Commercial Plans
RECEIVED
1/16/2026
DEPARTMENT OF
ENGINEERING
ENGINEERING
REVIEW COPY

SHEET TITLE: GENERAL INFORMATION SHEET			
		DRAWING NUMBER: G002			
NEW FIRE STATION #10 ST. TAMMANY FIRE PROTECTION DISTRICT NO. 1 2745 LAKESHORE VISTA BLVD SLIDELL, LA 70461		JOB NO: 2519	DATE: 12-03-2025	DRAWN BY: GSD	CHECKED BY: JMS
This drawing was prepared and issued under the supervision of the Professional Engineer named herein, who is duly licensed by the State of Louisiana. The Engineer's name and license number are shown on the drawing. The Engineer is responsible for the design and construction of the project. The Engineer is not responsible for the construction of the project. The Engineer is not responsible for the construction of the project. The Engineer is not responsible for the construction of the project.		This drawing was prepared and issued under the supervision of the Professional Engineer named herein, who is duly licensed by the State of Louisiana. The Engineer's name and license number are shown on the drawing. The Engineer is responsible for the design and construction of the project. The Engineer is not responsible for the construction of the project. The Engineer is n

SHEET TITLE:
PROPOSED SITE PLAN

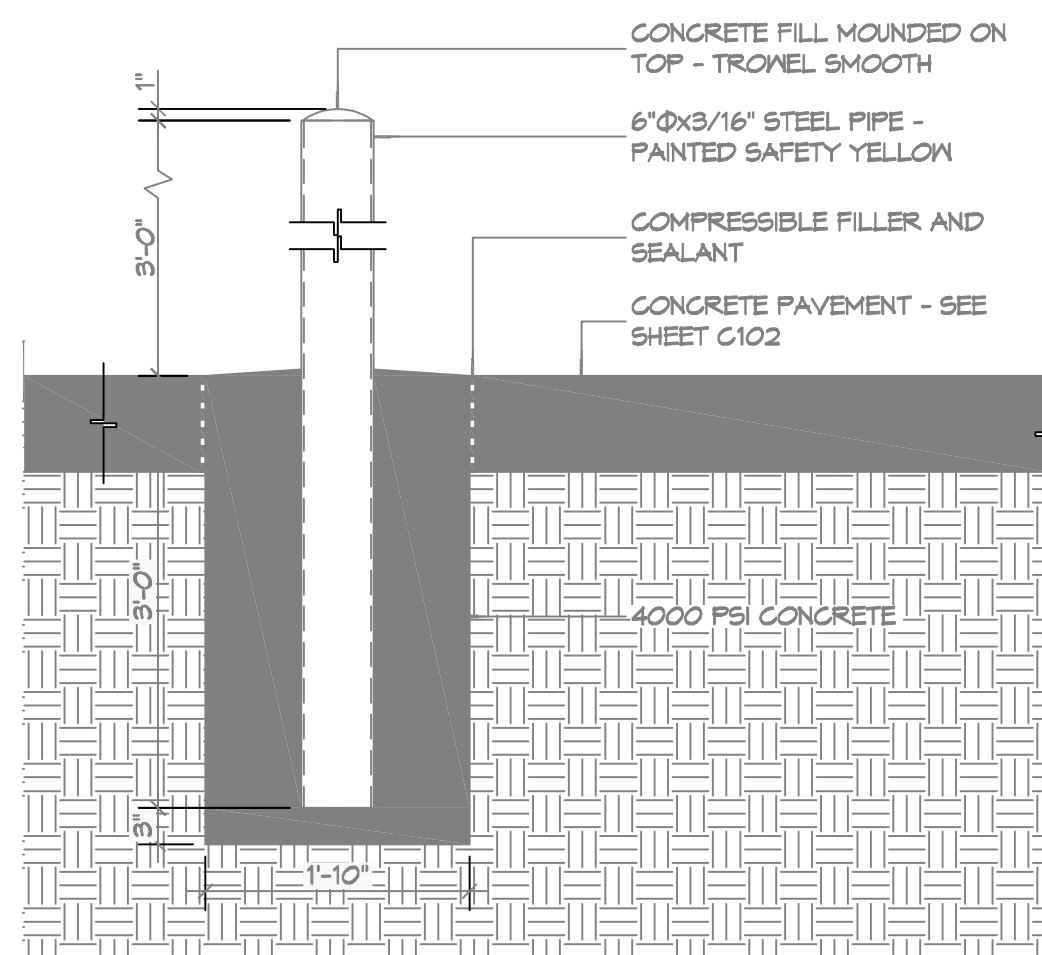
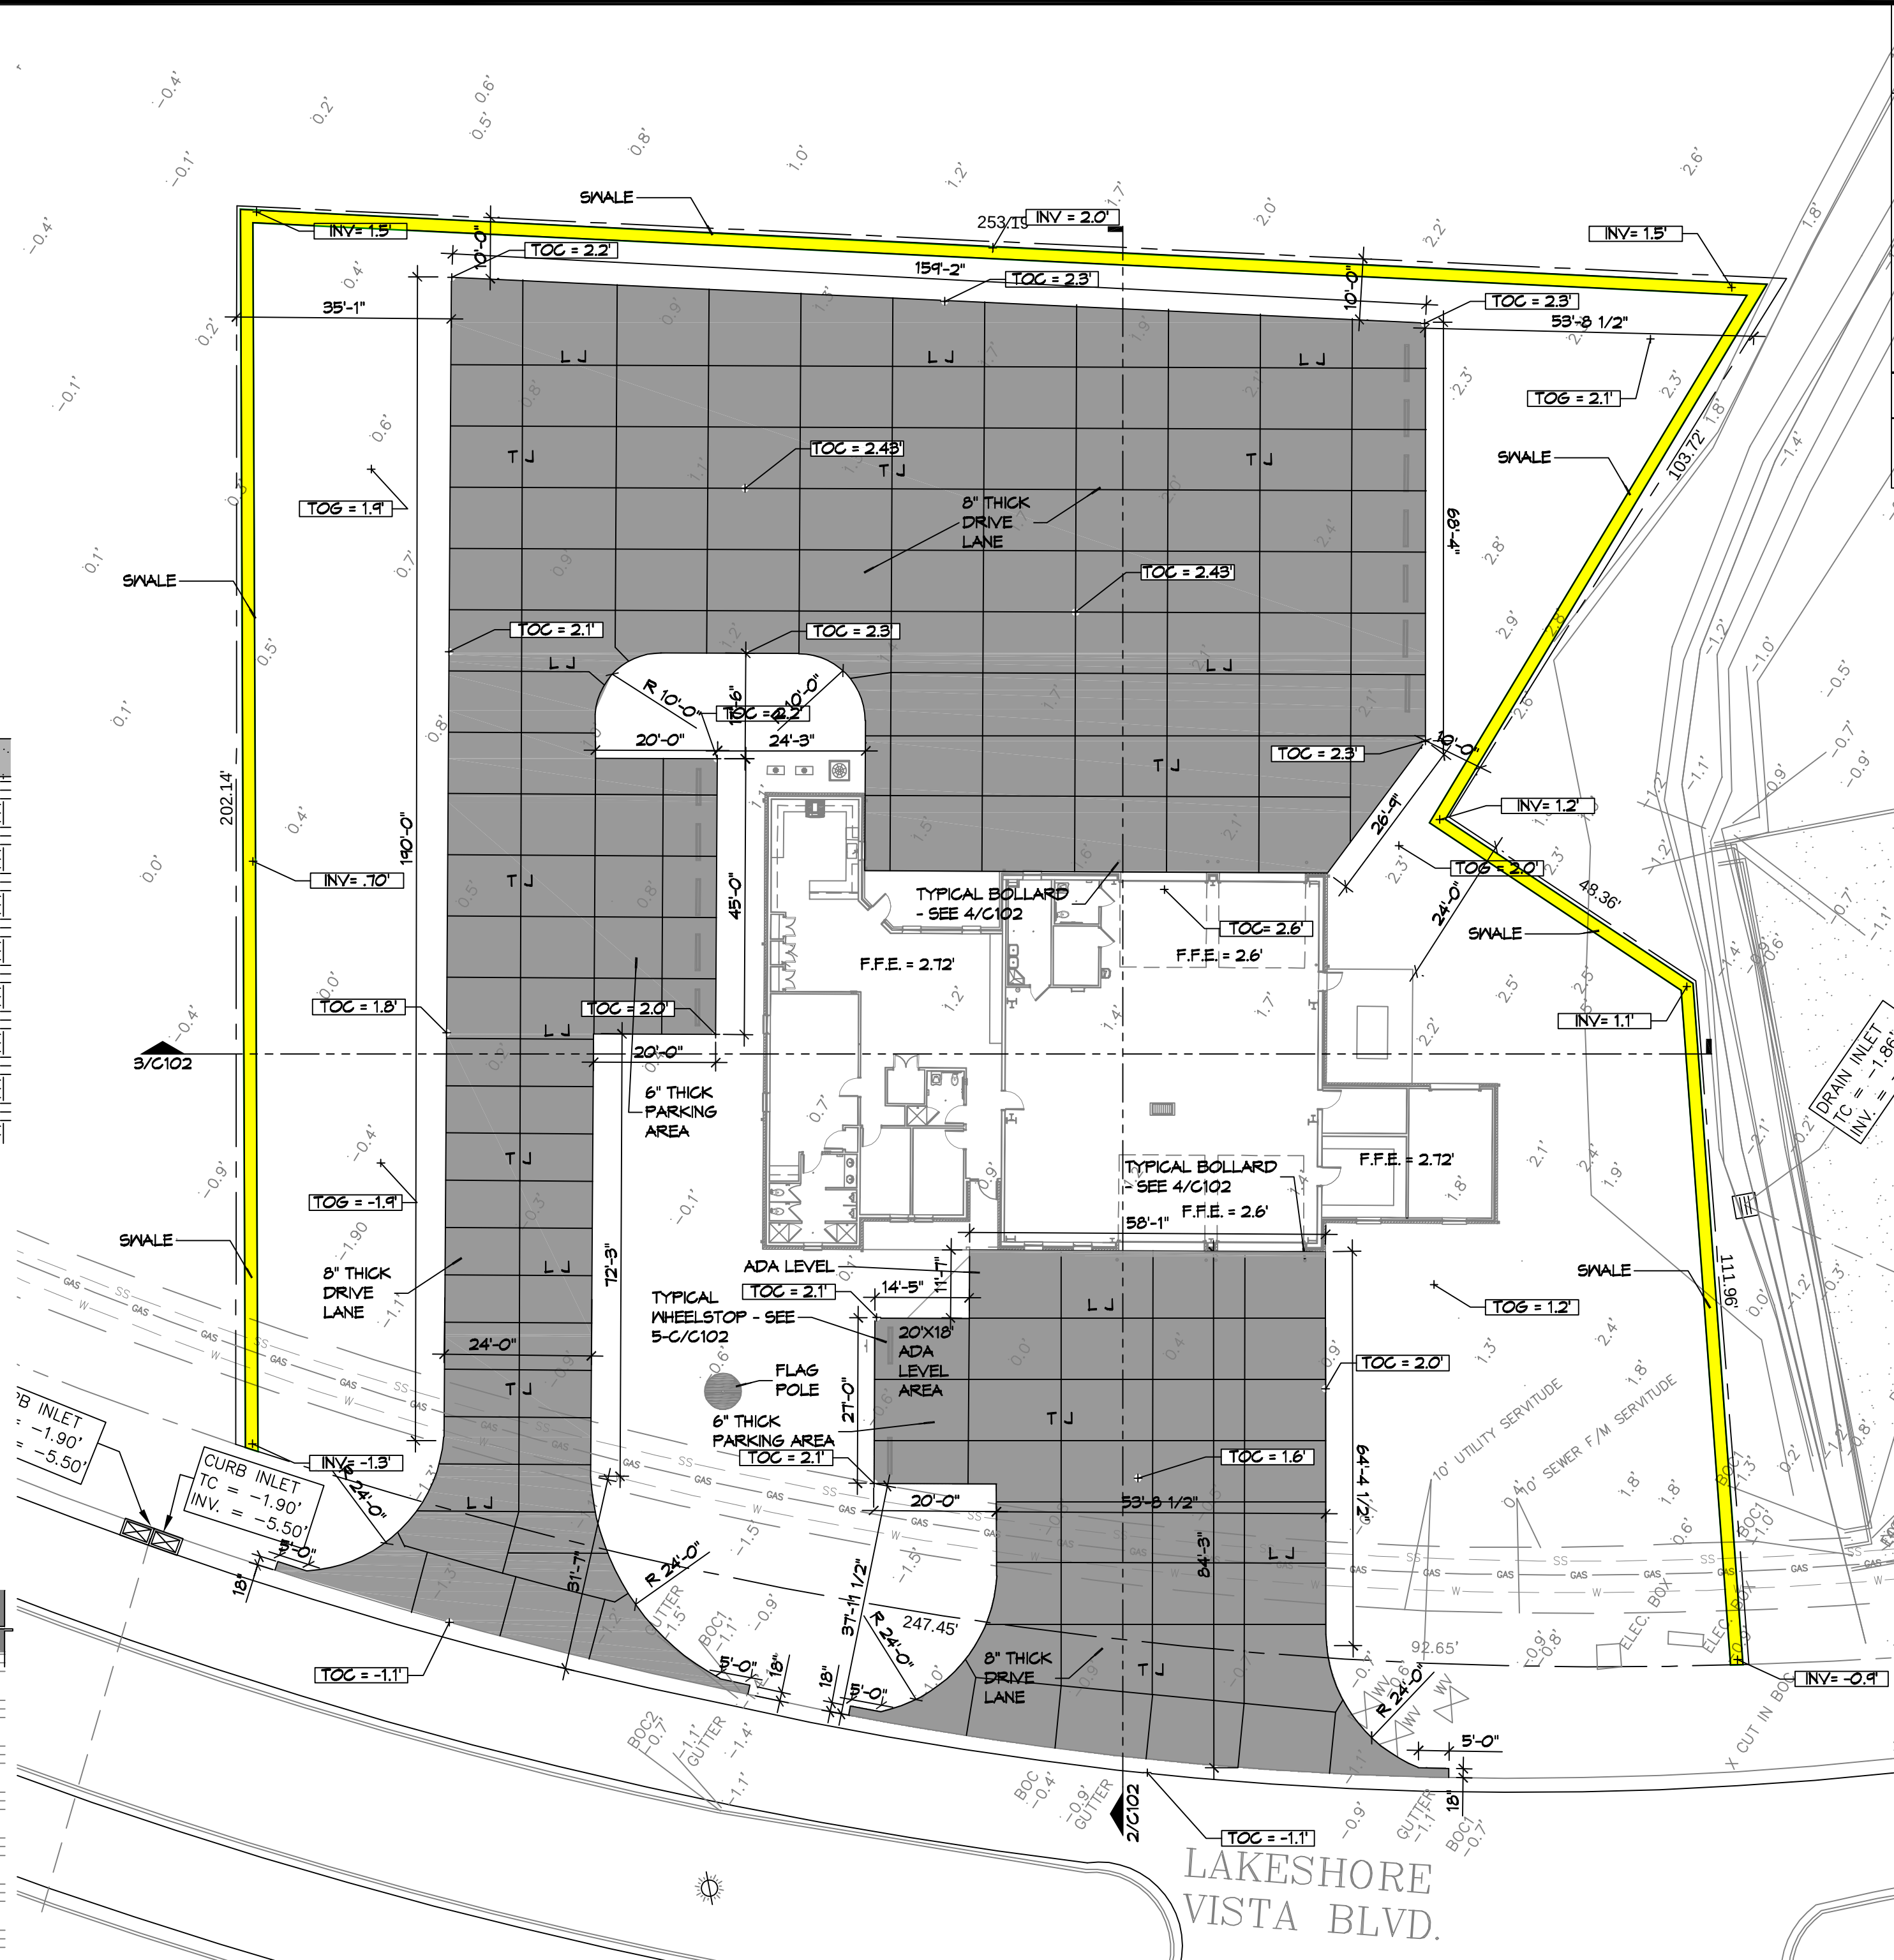
Revise to provide minimum 25' flared driveway radii. (TYP)

SHEET TITLE:
SITE PLAN - DRAINAGE
AND DETAILS

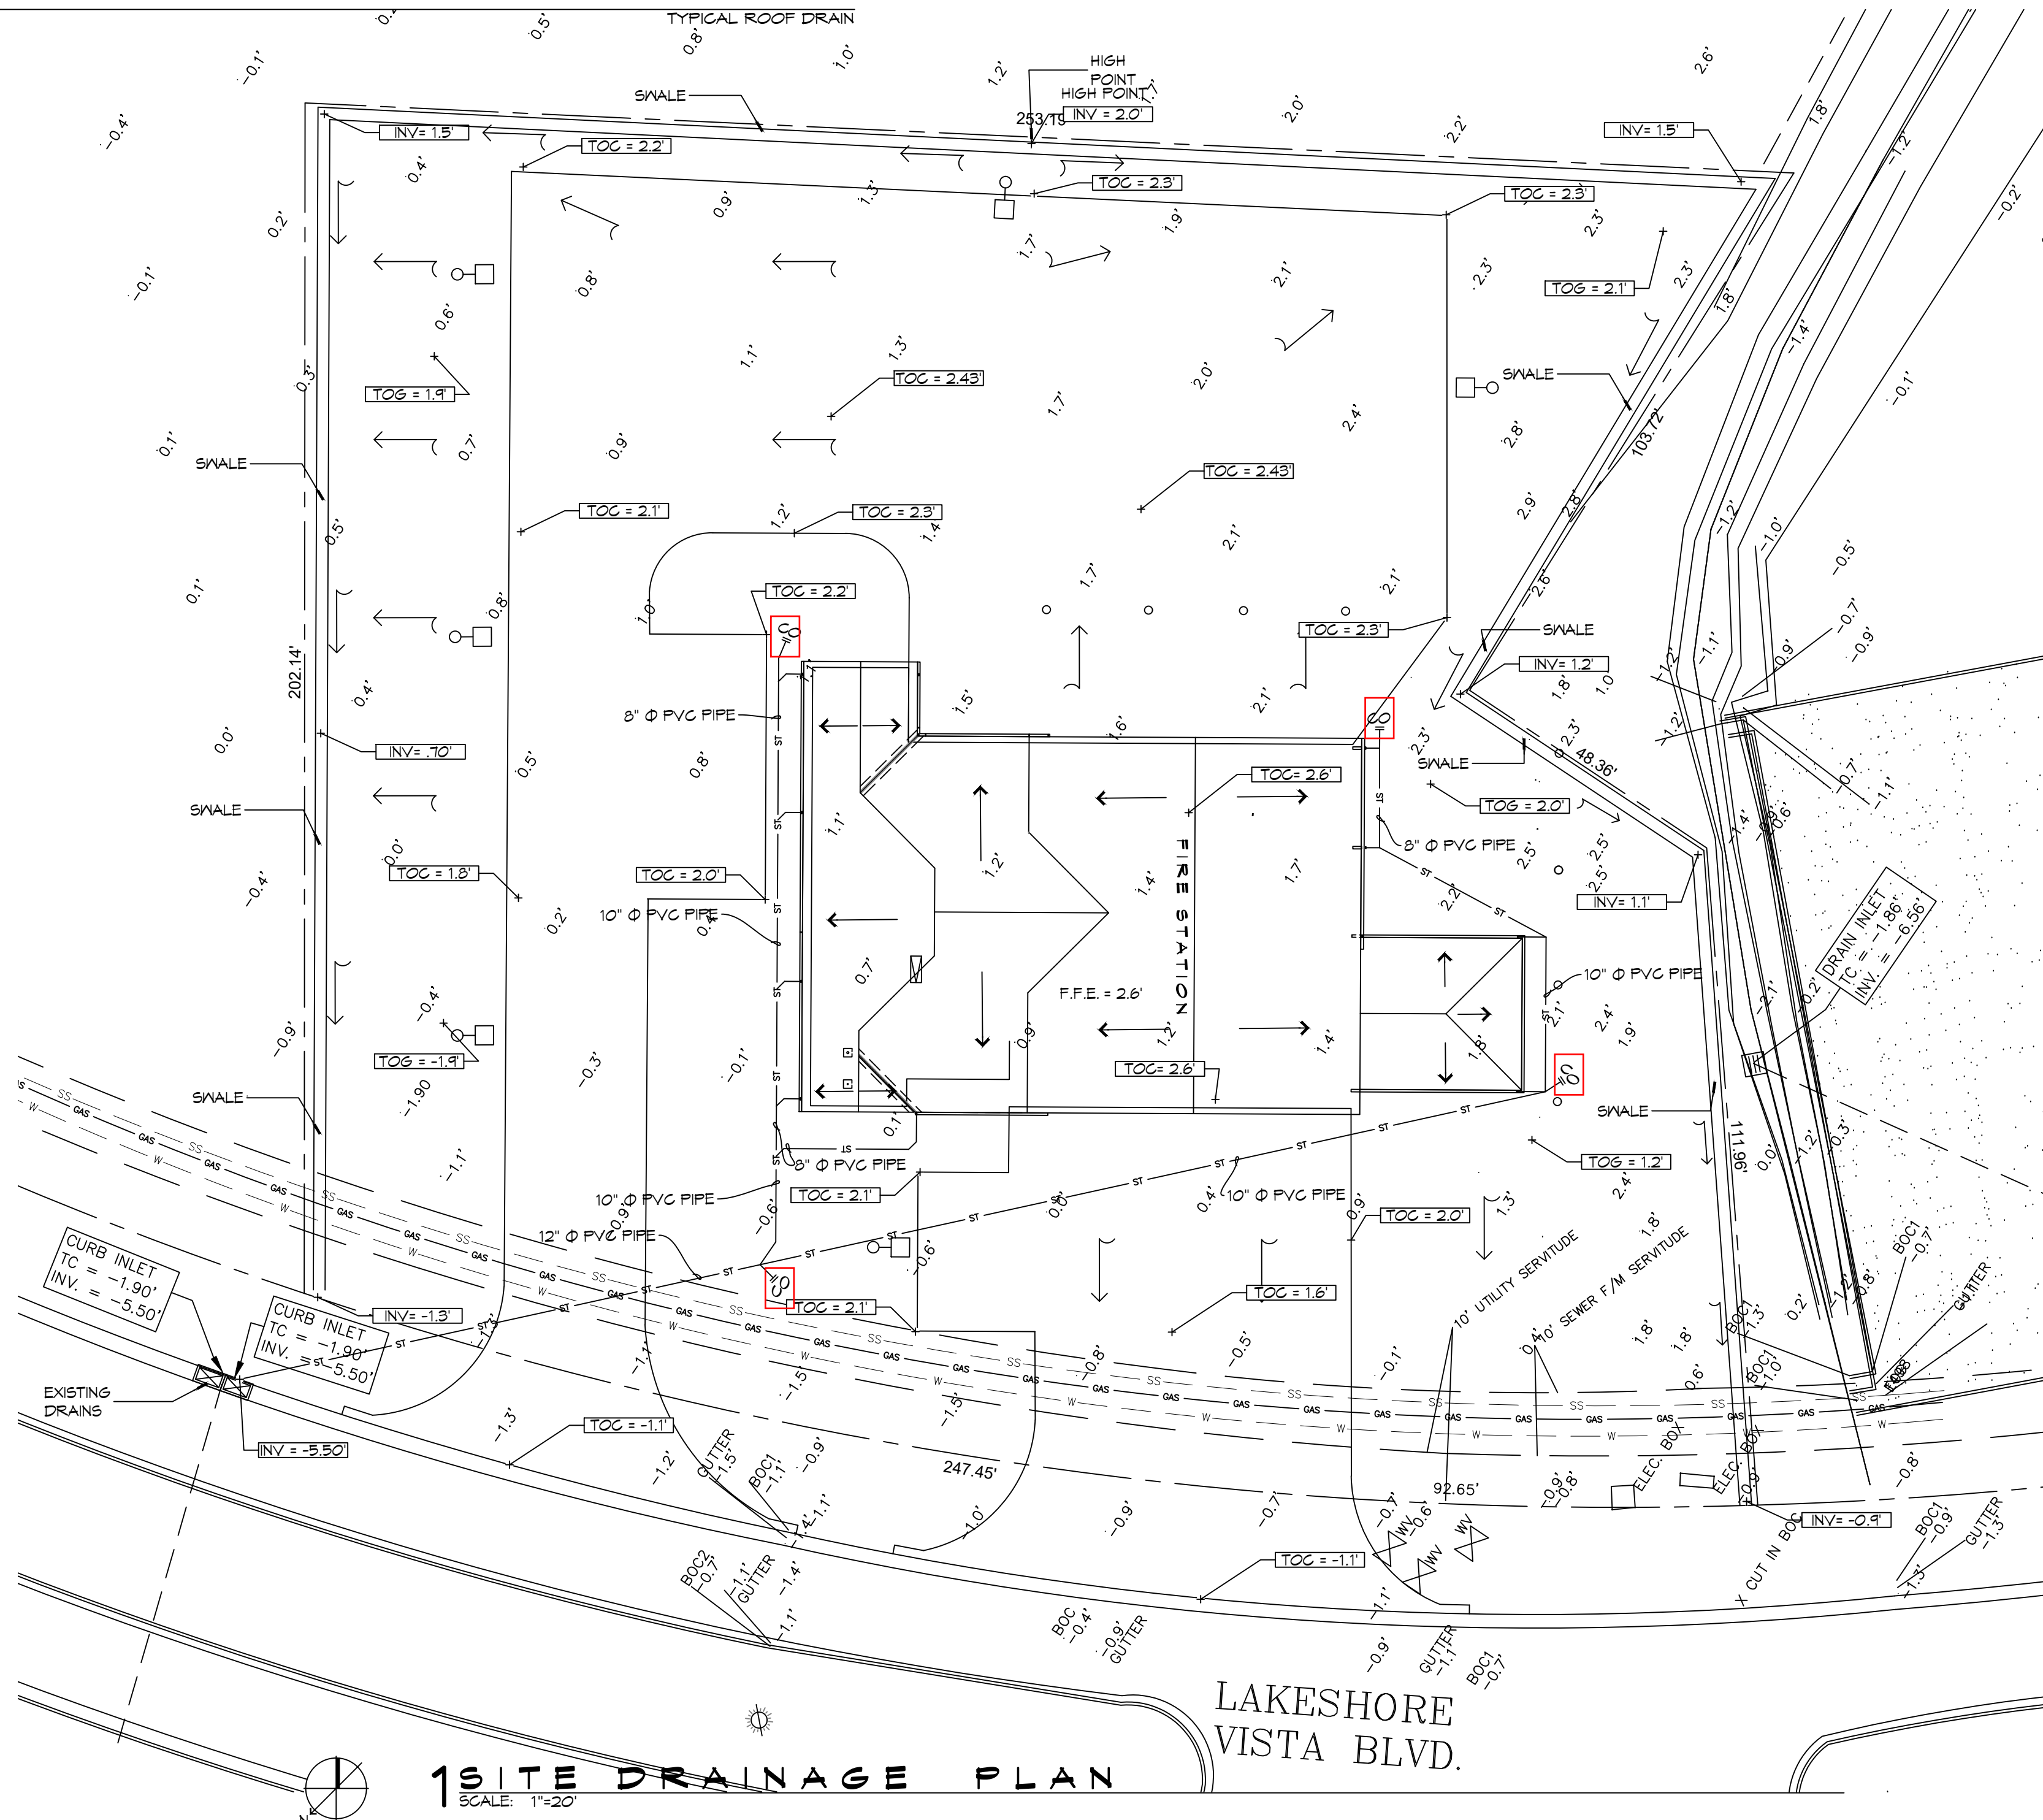
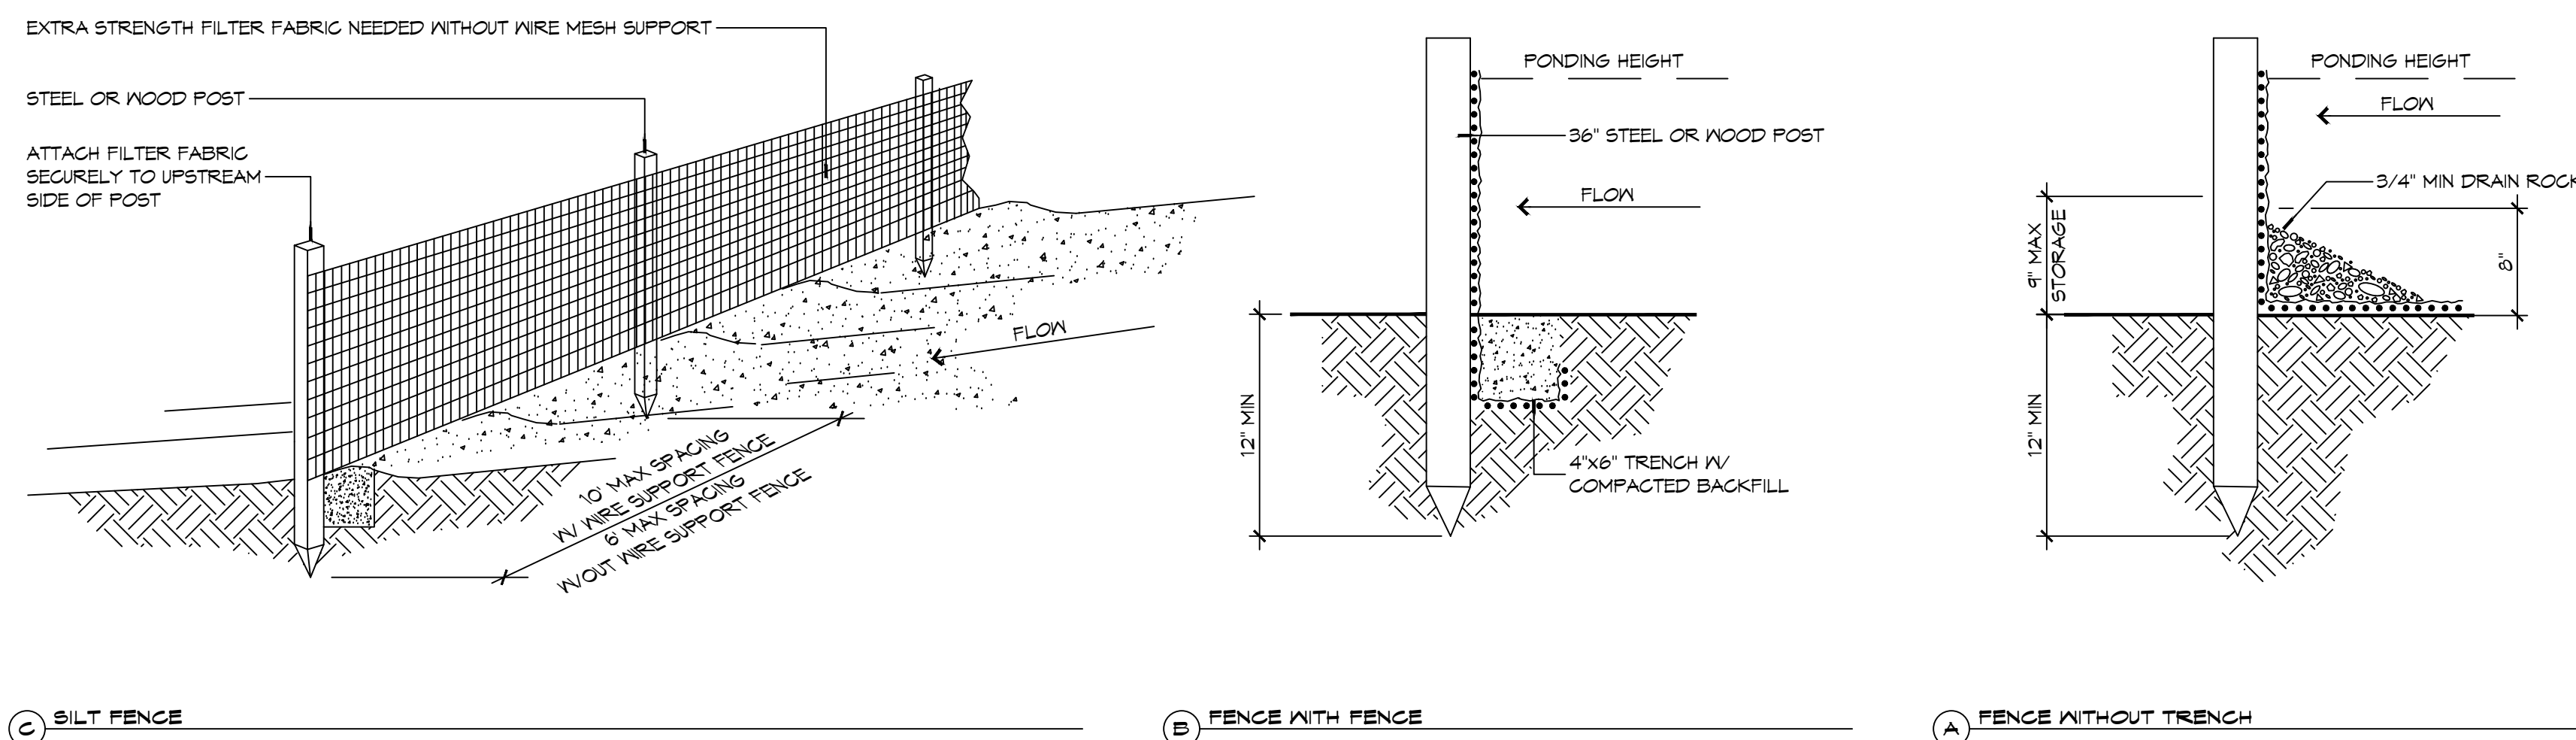
Provide proposed drain pipe invert elevations.
